# Intel<sup>®</sup> 815EG Chipset Platform for Use with Universal Socket 370

Design Guide Update

Document Number: 298601-002

#### 5. **Changed Figure 80, Trace Routing, in Section 11.9.2.1, General Trace Routing Considerations**

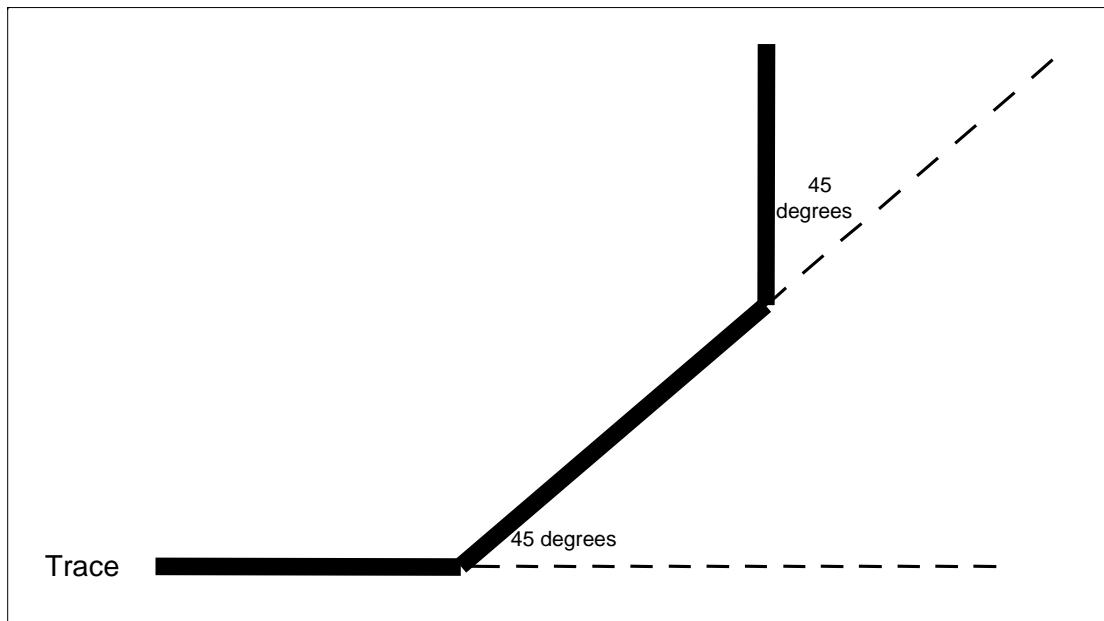
Figure 80. Trace Routing, in Section 11.9.2.1, General Trace Routing Considerations, is replaced with the following figure:

**6. Changed Figure 76, RTC Power Well Isolation Control, in Section 11.8.6, Power Well Isolation Control Strap Requirements**

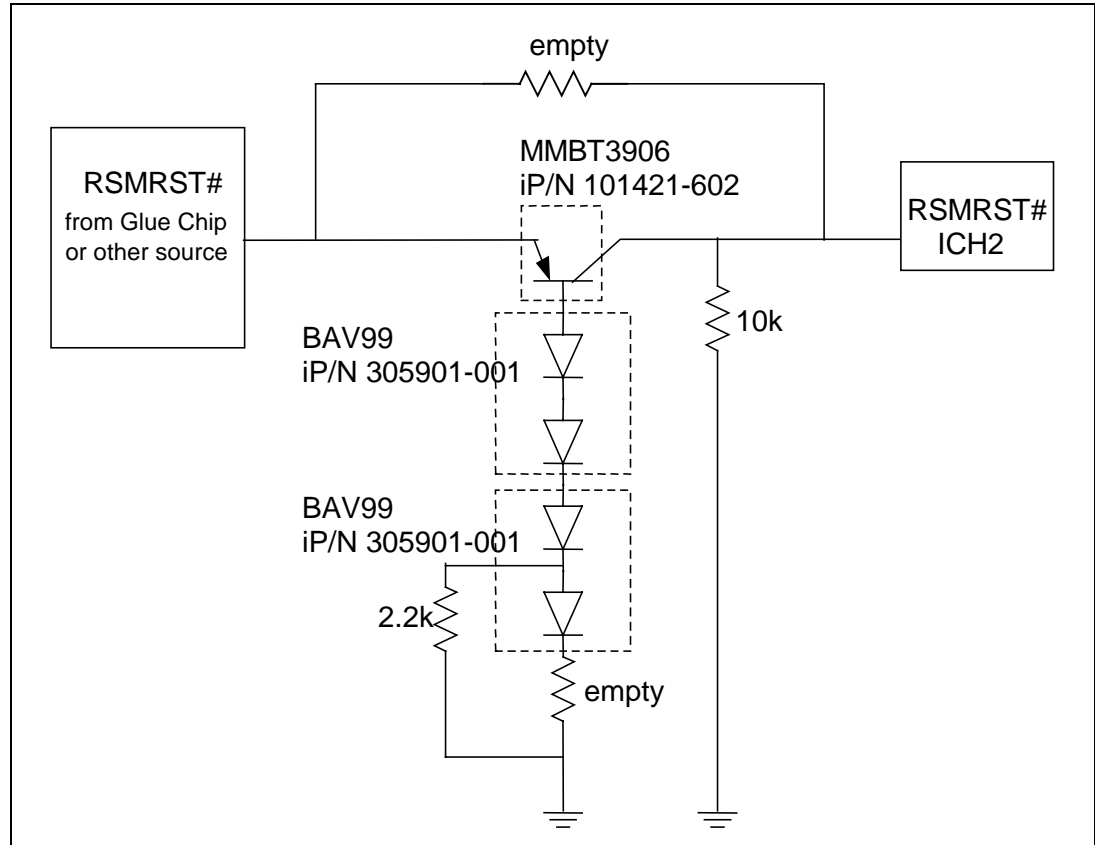
Figure 76, RTC Power Well Isolation Control, is changed to the following:
